CITY OF LA VISTA
MAYOR AND CITY COUNCIL REPORT
JULY 19, 2016 AGENDA

Subject:	Type:	Submitted By:
APPLICATION FOR PRELIMINARY PLAT, LOTS 1-7, BRENTWOOD CROSSING, LOTS 8B & 8C, BRENTWOOD CROSSING REPLAT NO. 1, LOTS 8A1, 8A2, 8A3 & 8A4, BRENTWOOD CROSSING REPLAT NO. 2, AND PORTIONS OF TAX LOT 12, 14-14-12; AND WAIVER OF SECTION 4.24, SUBDIVISION REGULATIONS (SE OF 84 TH & SUMMER DR.)	◆ RESOLUTION ORDINANCE RECEIVE/FILE	ANN BIRCH COMMUNITY DEVELOPMENT DIRECTOR

RE: Preliminary Plat – Initial Review
La Vista City Centre

RE: Preliminary Plat – 2nd Review
La Vista City Centre

SHEET C1.1
drawn by: CAS
checked by: ERG
approved by: ERG
Co/Co by: ERG
project no.: 016-0546
drawing no.: 04.04.2016
date: 04.04.2016

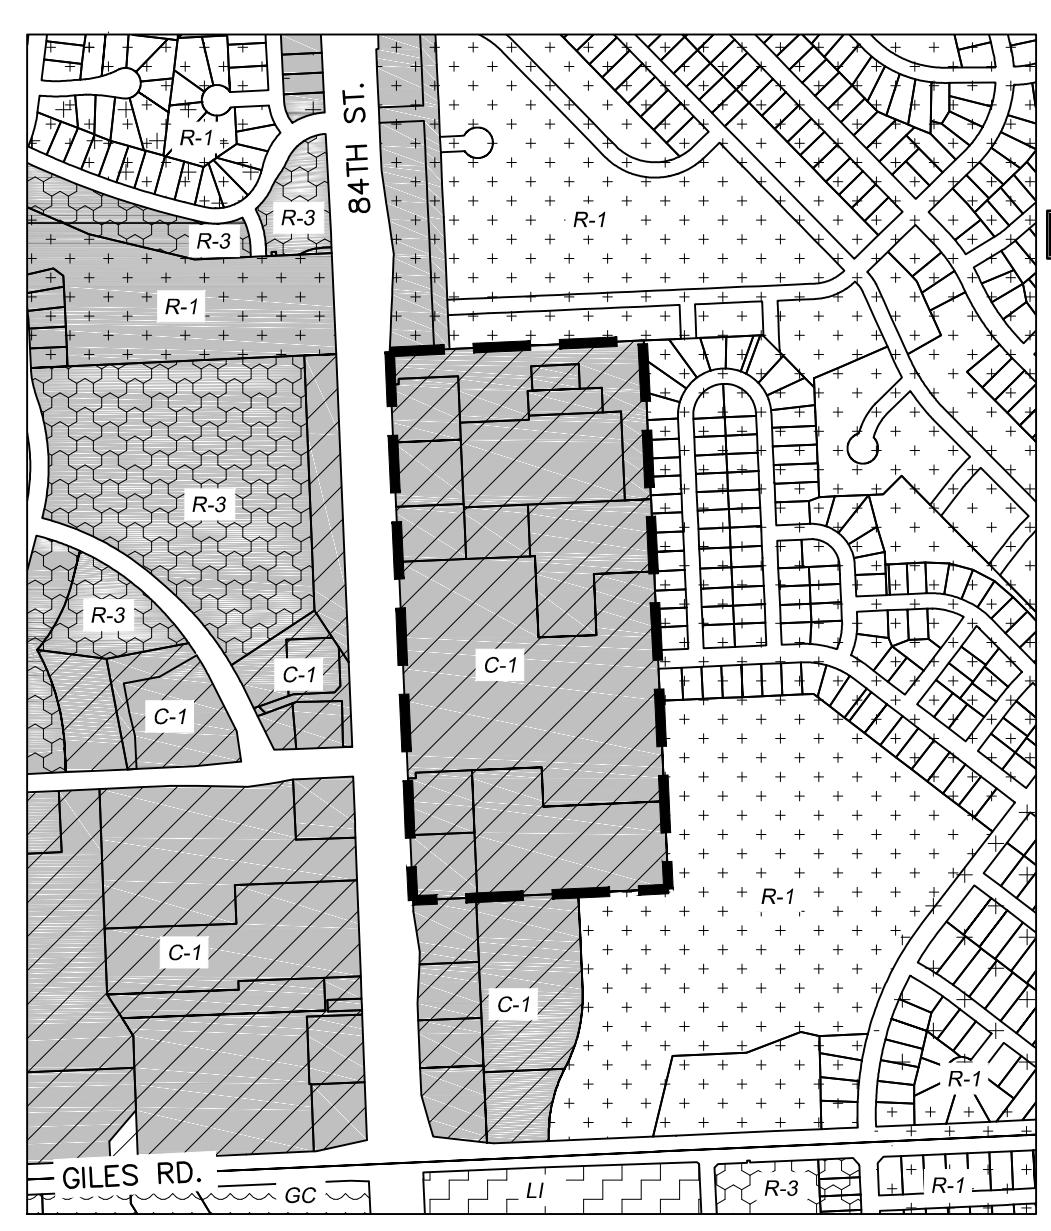
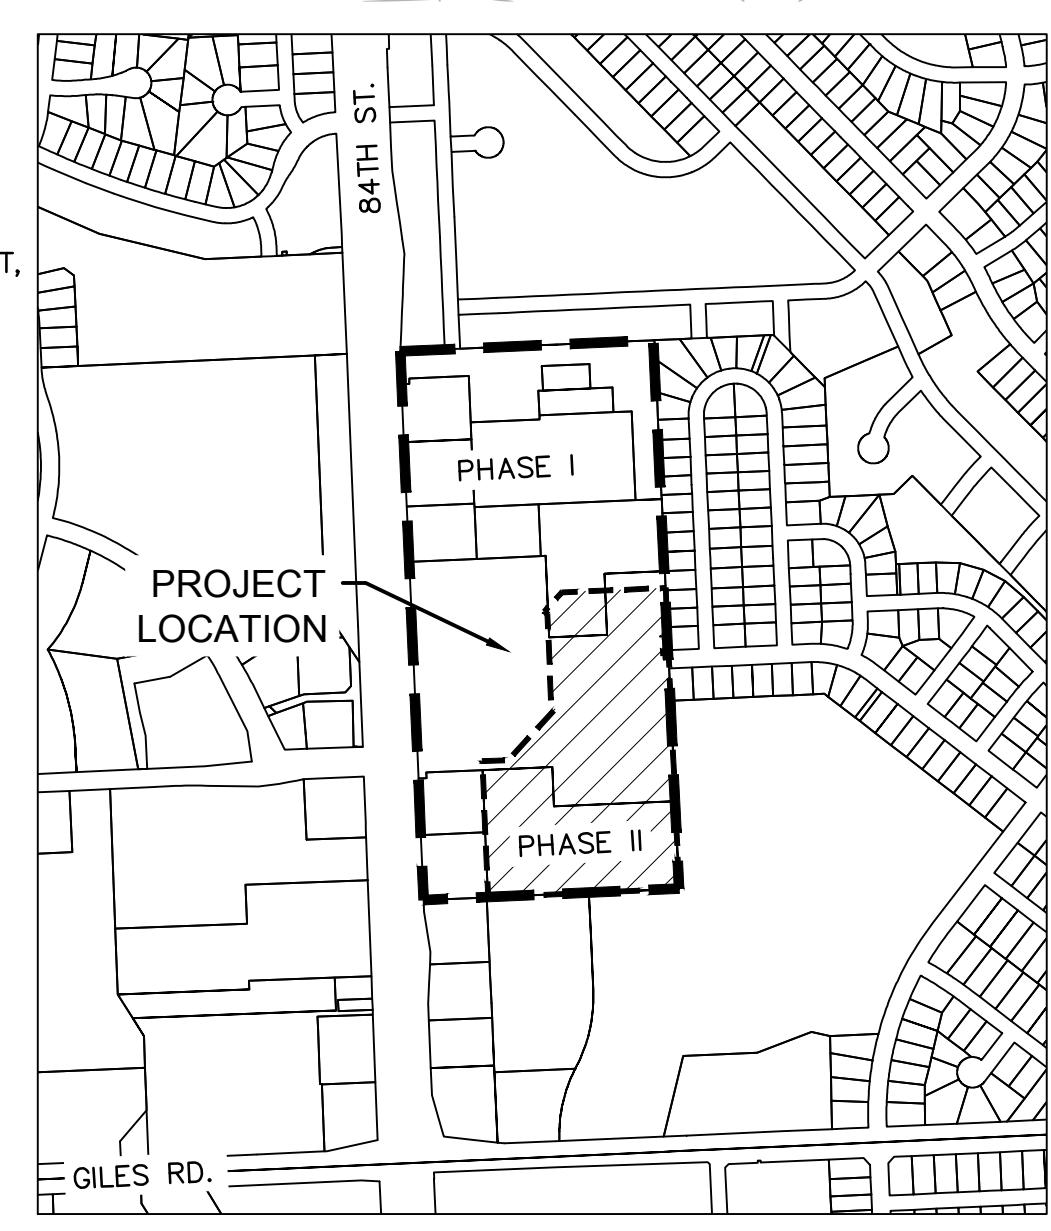
4. The existing easements on the property need to be illustrated on Sheet C1.1. This is needed in order to determine what releases and/or relocation of easements are required. This is particularly important with easements connected to Wiltham Place to the south. There is also an existing public sidewalk easement along the south side of the property.

5. The proposed “land swap” on Sheet C1.1 needs clarification as to what is being swapped for the shaded area. This might be clarified in a draft subdivision agreement if illustration on the plans is not practical. At a minimum, the acreage of the areas needs to be delineated on the map.

6. To satisfy Article 3.03.06 of the Subdivision Regulations the legal description of the property as currently platted needs to be set forth on Sheet C1.1 with a statement of the total acreage involved in the proposed platting. This would include the proposed portions of the golf course property to be incorporated into the project.

9. The centerline radii of proposed public streets need to be identified on Sheet C1.1. These radii need to comply with the Nebraska Board of Public Roads Classifications and Standards as well as the Subdivision Regulations, Section 4.24. The Board of Public Roads Classifications and Standards allows for local streets to have minimum horizontal centerline radii of 100 feet if the roads will have a design speed of 30 mph or less. However, Section 4.24 of the Subdivision Regulations requires 200 feet radii for local streets and 100 feet radii for cul-de-sac streets. The City Engineer recommends a minimum of 100 feet centerline radii. A waiver for local streets minimum centerline radii will be needed if the proposal is less than 200 feet.

12. Proposed easements for utilities need to be shown per Article 3.03.12. For example, there are proposed water mains crossing Outlots A, B and C. Will there be blanket easements over these outlots? Also, there is a note on Sheet C1.1 that "standard utility dedications" will be provided on the final plat. Staff

13. The existing zoning is listed on Sheet C1.1 as C-1 Shopping Center District. Please revise to include the Gateway Corridor Overlay District. Also please revise the Existing Zoning Map to depict the Gateway Corridor Overlay District as well. Future zoning will have the MU-CC district as shown, without the Gateway Corridor district.

Response: Existing easements are now shown

Response: Acreages have been added to the plat. The specifics of the swap are planned to be clarified in the subdivision agreement.

Response: A legal description has been added

Response: All centerline radii have been updated to 100'. A waiver for the reduction in centerline radii from 200' to 100' is attached to this resubmittal.

Response: The utilities have been routed around the proposed Outlots. In addition the note referring to standard utility dedications has been removed.

Response: This has been noted on the plat

SHEET
C2.1

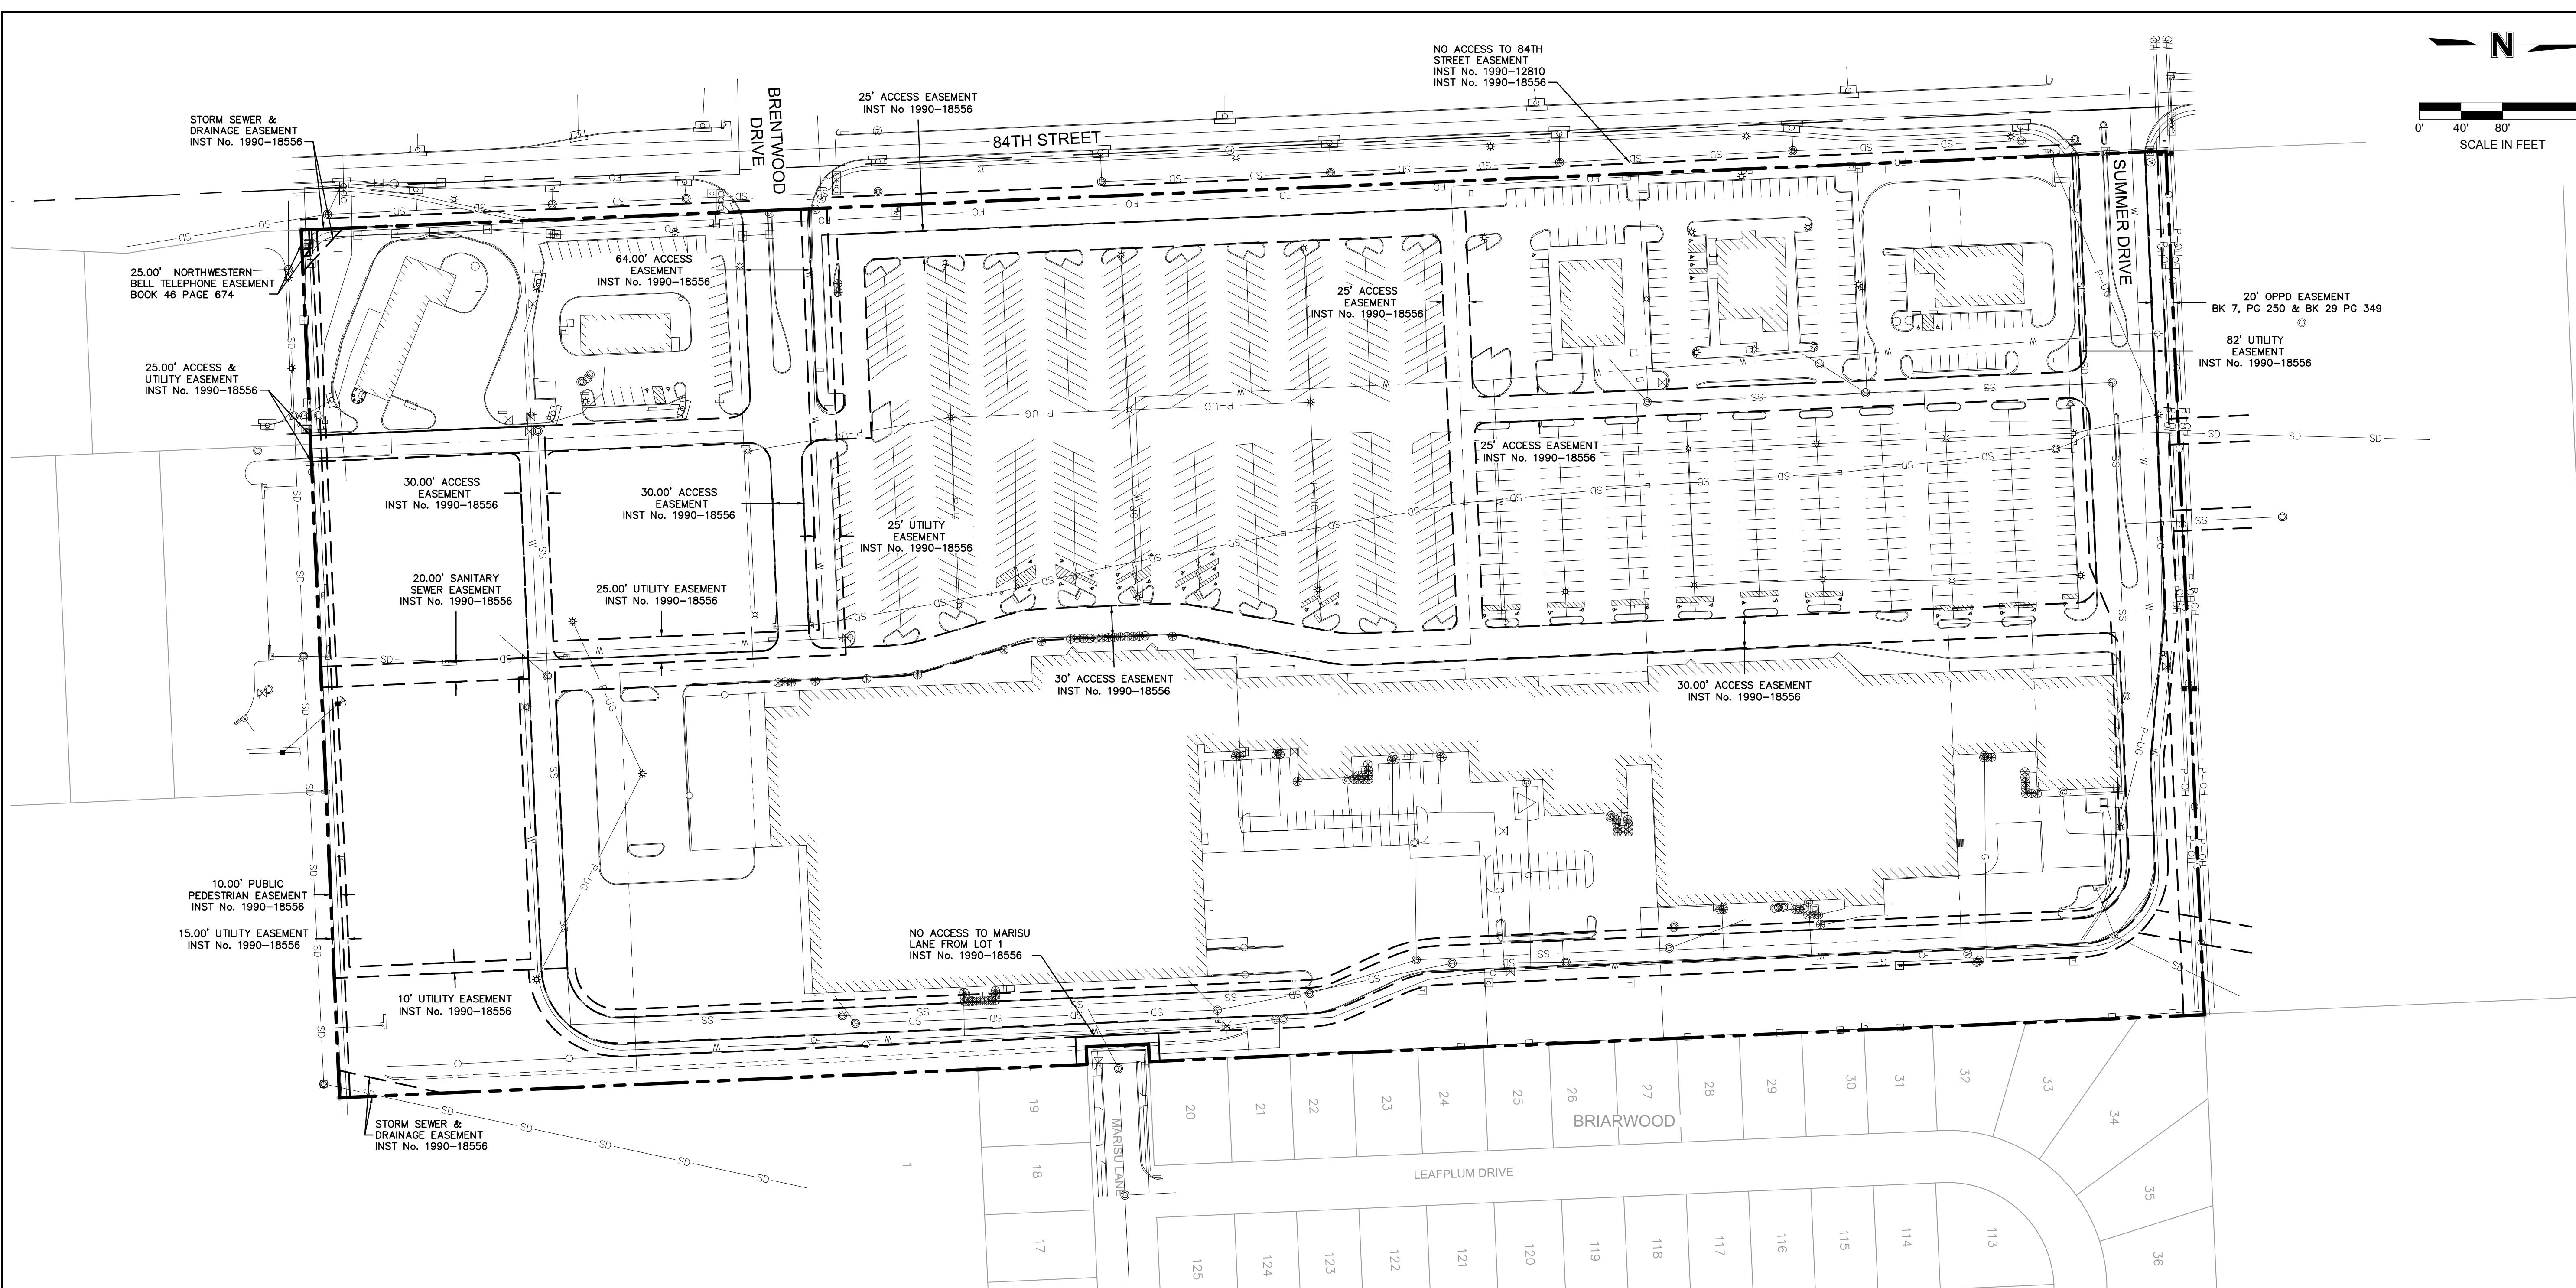
8. There is an existing sanitary sewer that connects to Wiltham Place in the existing sewer easement shown on C2.1. The proposed utility plan on Sheet C3.1 will need to provide for reconnecting that sewer and relocating as appropriate.

Response: Sewer service will be provided to Wiltham Place
